**Field Service
TECH TIP
NEWS**

RI-0009

IA-28 CHIME MODULE

FALSE TRIGGERING

FOIL SIDE

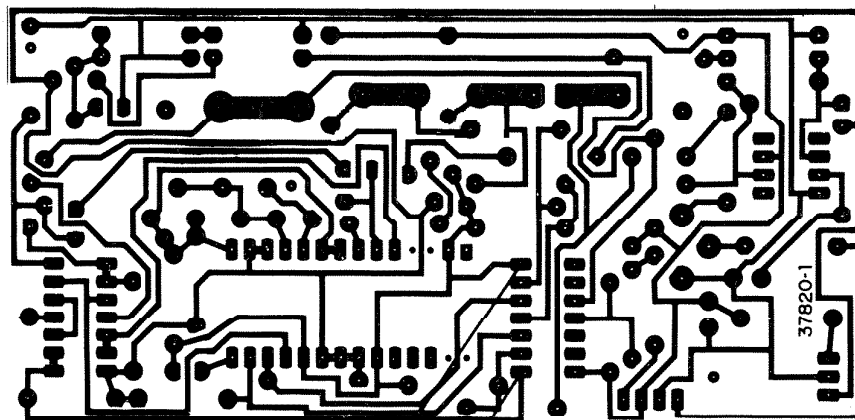
Occasionally false triggering due to transients may occur in Models IM-2003, IM-3003 and IM-3103 when using the IA-28 chime modules.

To correct this situation, install a 2.2 MFD electrolytic capacitor across pins 1 and 7. (Pin 7 is negative ground) on ICZ-3.

2.2 mfd
10 VOLTS

**OBSERVE
POLARITY**
